Document D
Red Lined Civil Drawings

Request for removal of street trees, and replacement of street light poles with wall sconces

PRELIMINARY & FINAL SITE PLAN
OF
LOT 3 OF BLOCK 15
BOROUGH OF SEA BRIGHT MONMOUTH COUNTY NEW JERSEY

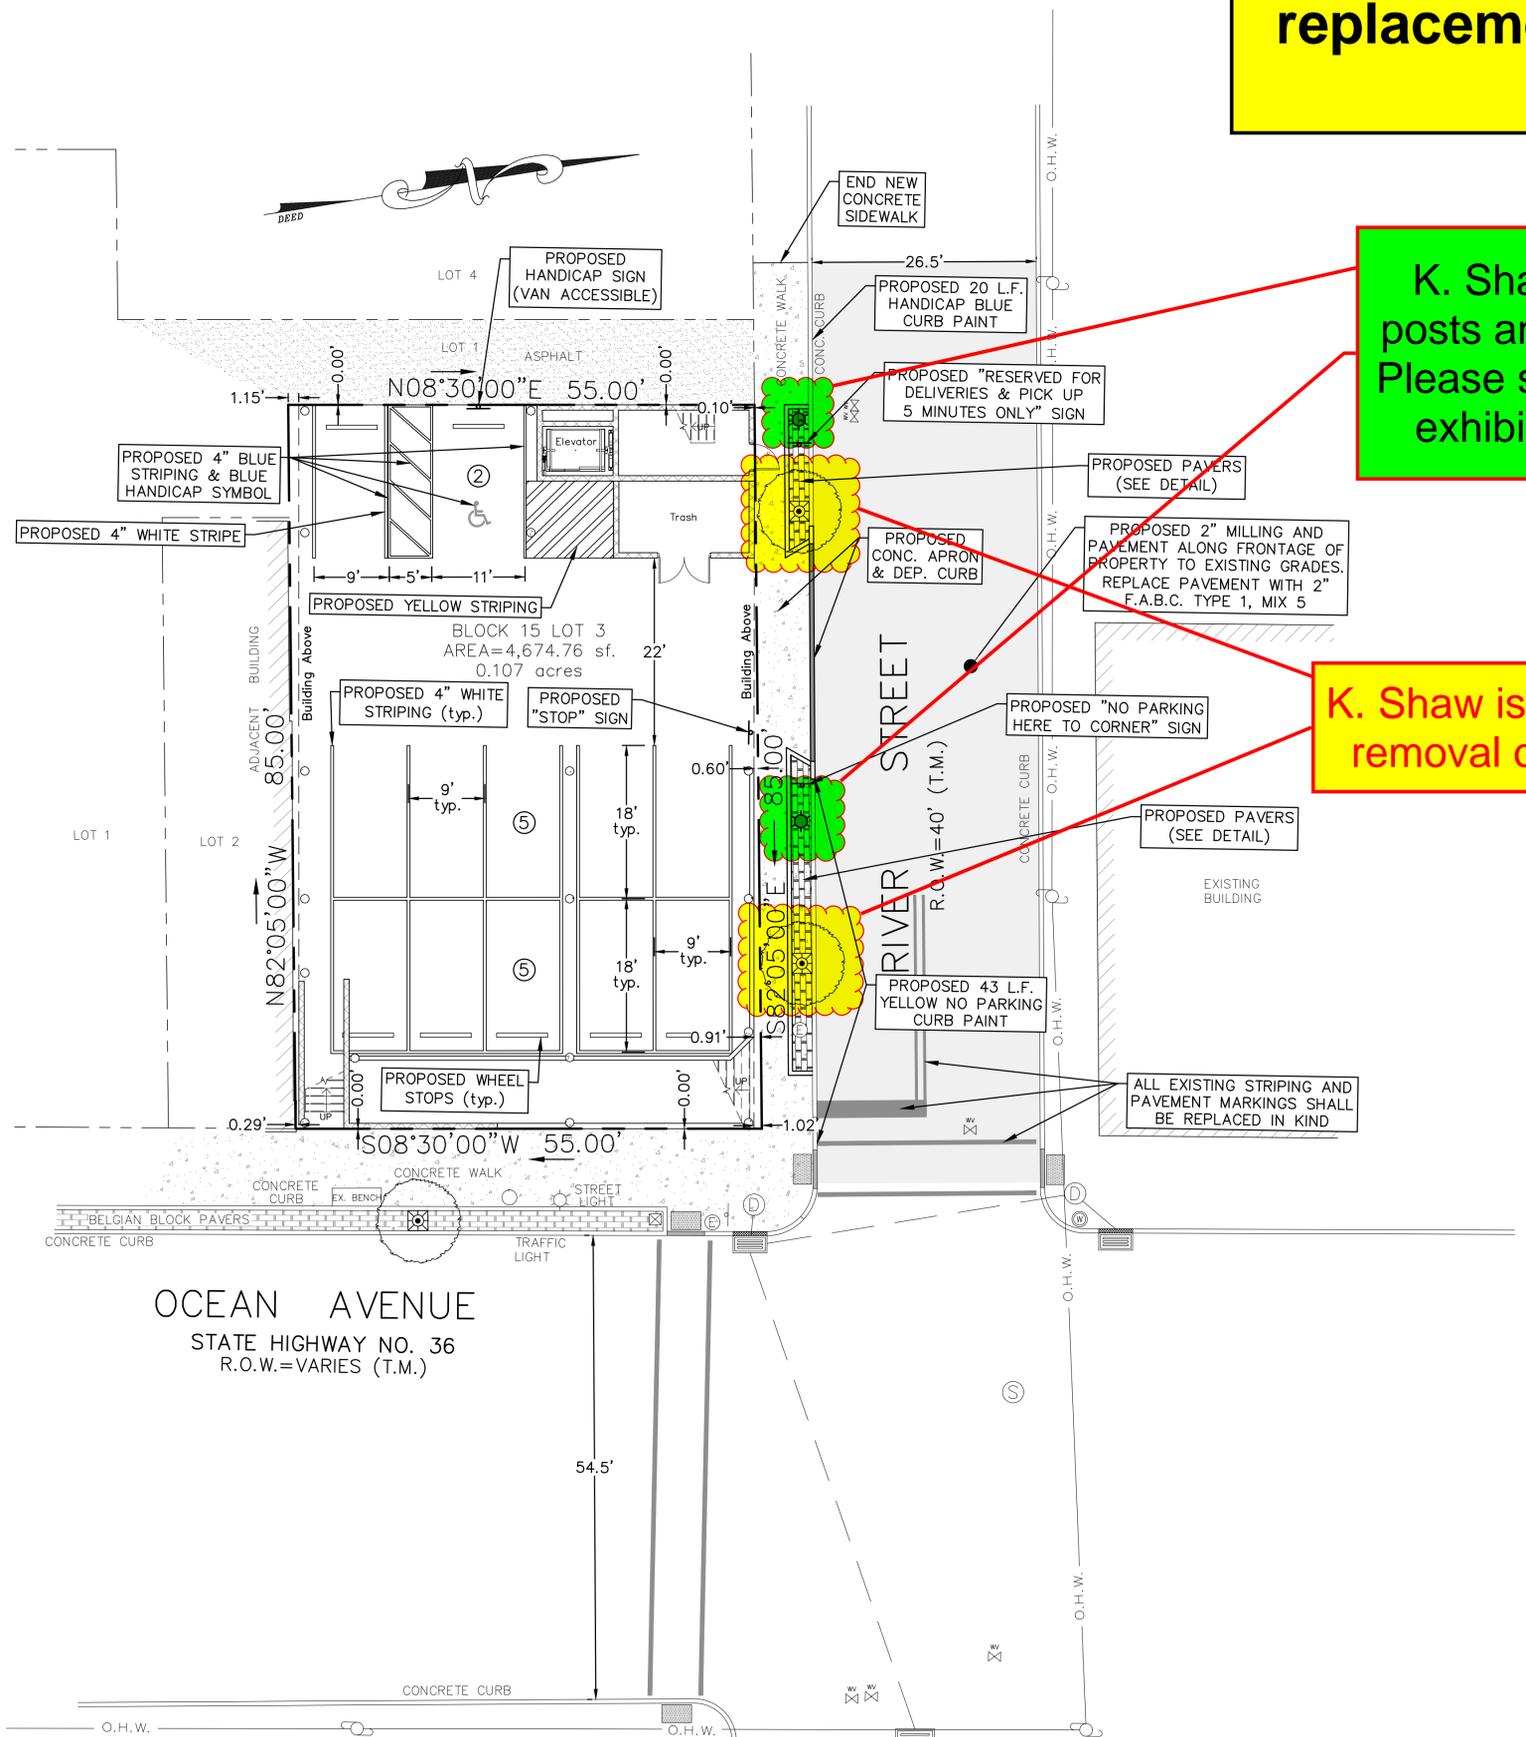
K. Shaw is proposing removing these light posts and replacing with similar wall sconces. Please see exhibit A for cut sheet. Please see exhibit B for proposed location of sconces

K. Shaw is proposing the removal of these trees

DIMENSION PLAN

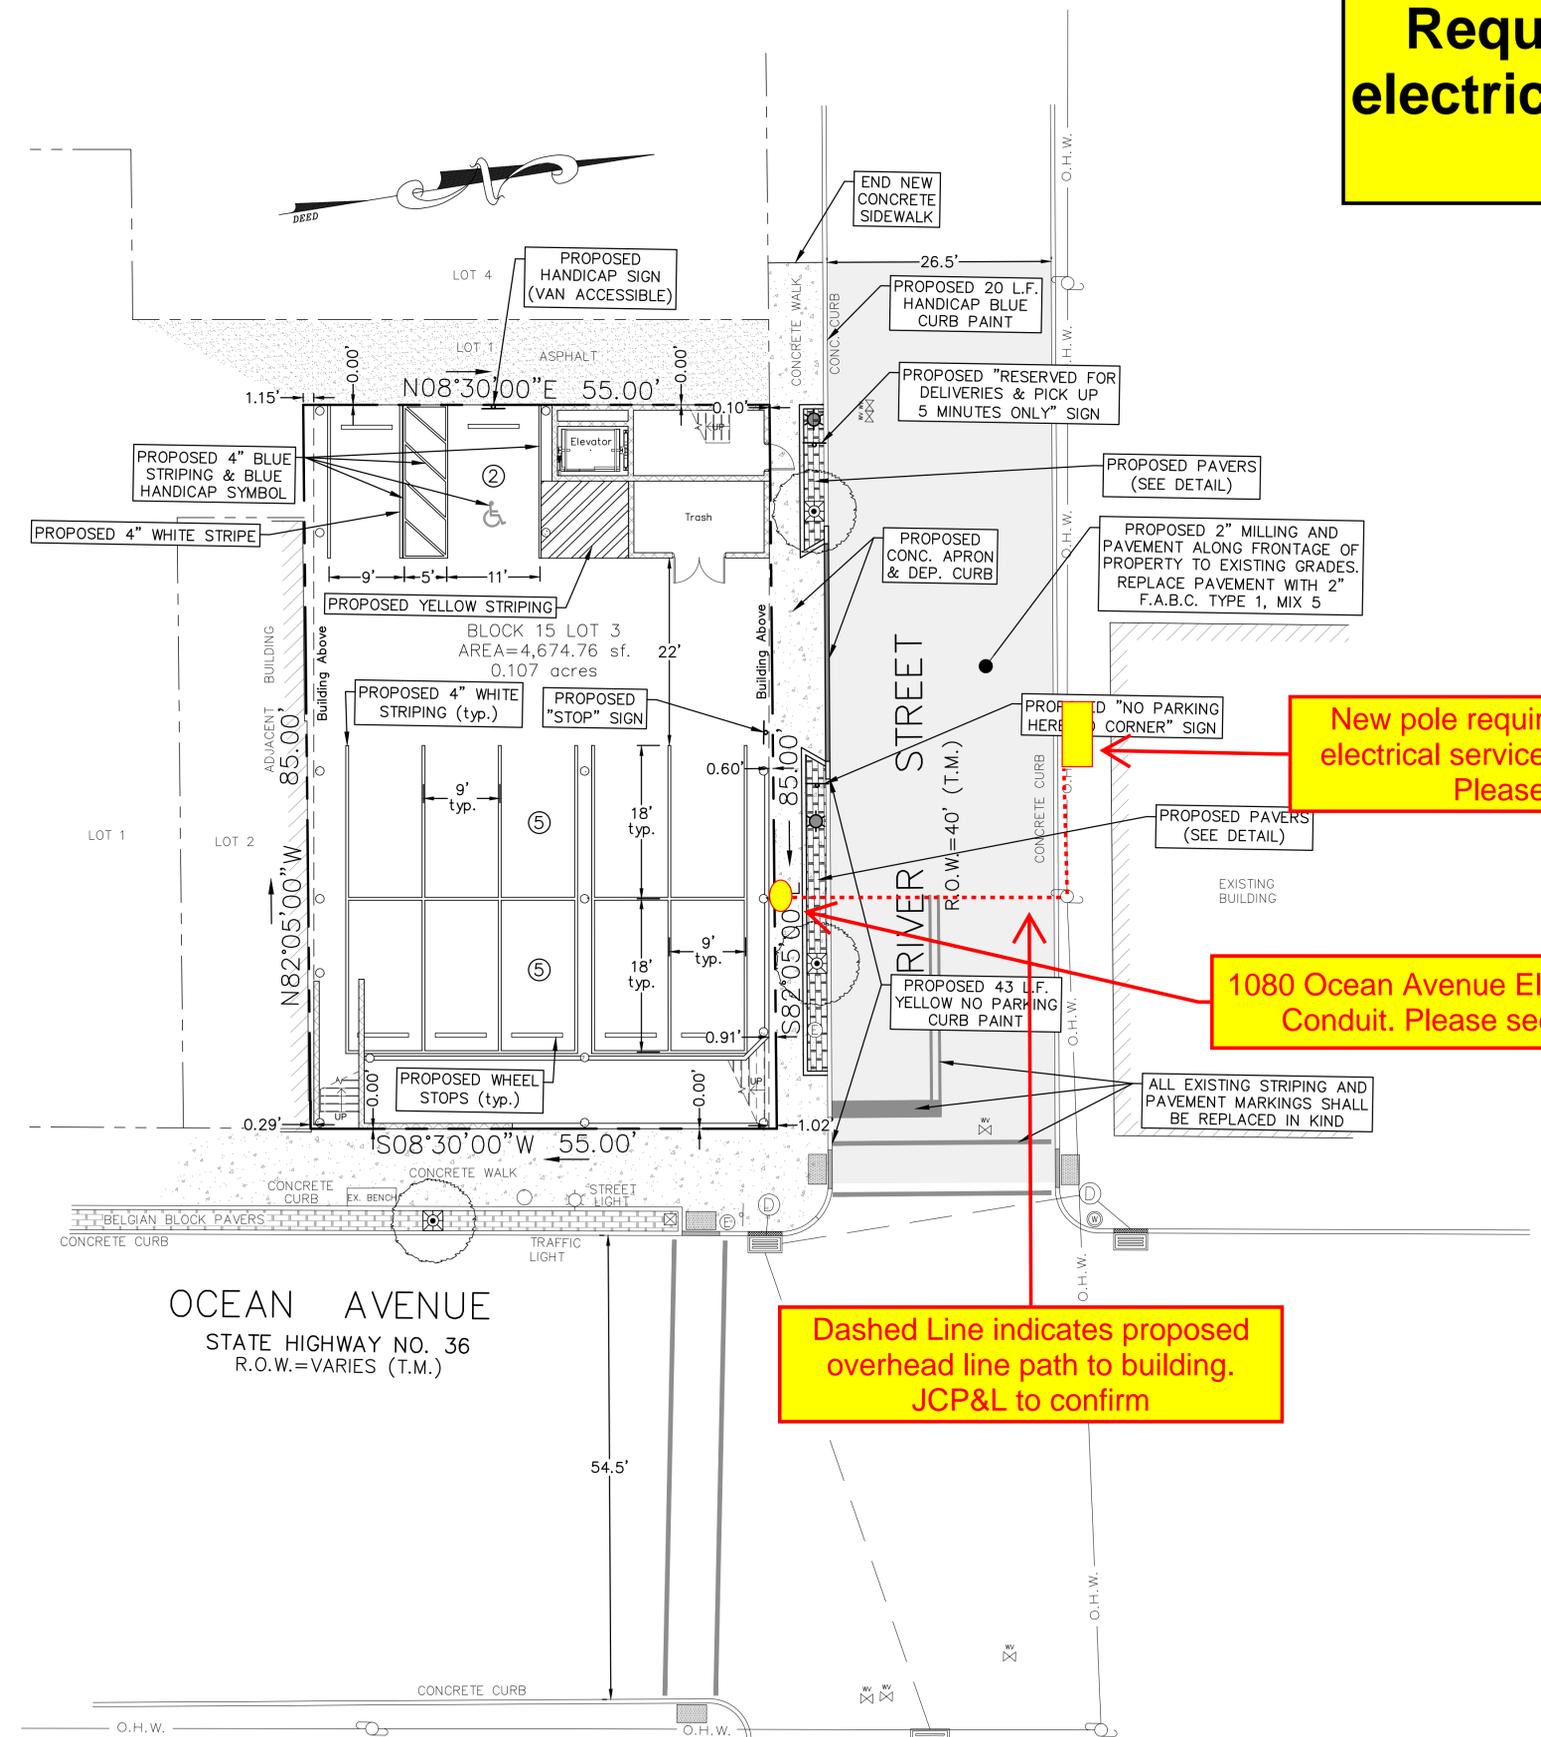
Request for installation of overhead electrical service in lieu of underground electrical service

New pole required by JCP&L to provide electrical service to 1080 Ocean Avenue. Please see Exhibit D.

1080 Ocean Avenue Electrical Service Conduit. Please see Exhibit C.

Dashed Line indicates proposed overhead line path to building. JCP&L to confirm

Exhibit B

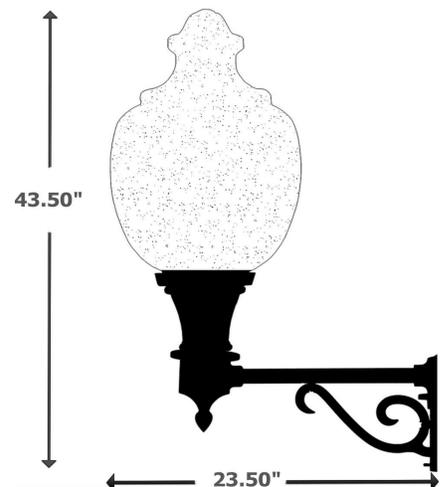
Green ovals indicate general location of street poles

Yellow Boxes indicate proposed wall sconce locations
